Rezoning Transportation Analysis

Petition Number: 2023-095

Date	Description
9-28-23	First Review (IW)
11-27-23	Second Review (ME)
12-20-23	Third Review (IW)
01-24-24	Fourth Review (KC)

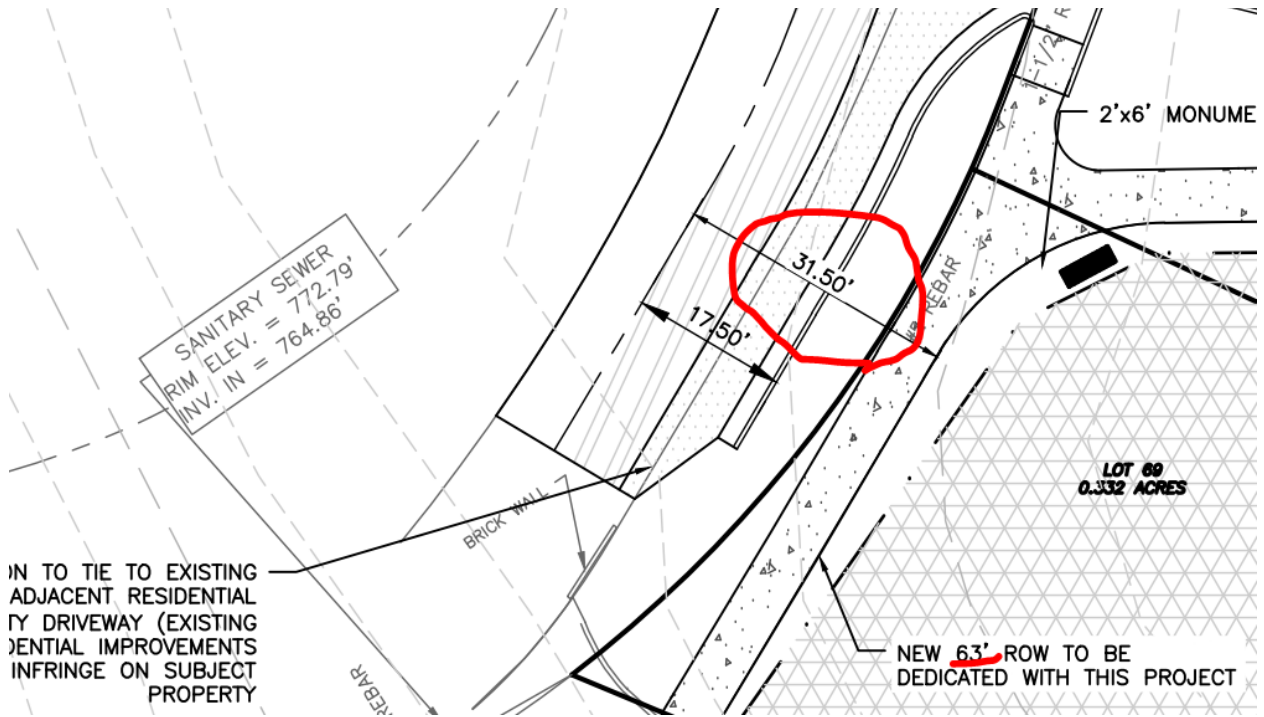
3. Outstanding Comment: Revise site plan and conditional note(s) to commit to dedicate 31.5 feet of right-of-way from the road centerline. The site plan shall label and dimension the right-of-way from the road centerline.

Clarifying Comment 11-27-23: Please revise site plan and conditional note to commit to mentioned right-of-way dimension with labeling and dimensioning from the roadway centerline.

Clarifying Comment 01-24-24: Please revise site plan and conditional note(s) to commit to dedicate 31.5 feet of right-of-way. The site plan shall label and dimension right-of-way from the centerline of the road.

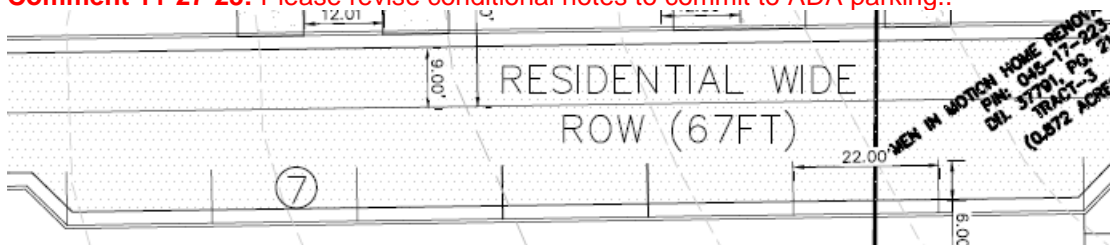
6. ~~Revise site plan and conditional note(s) to commit to providing an ADA on-street parking space to meet Federal ADA guidelines.~~

Comment 11-27-23: ~~Please revise conditional notes to commit to ADA parking.~~
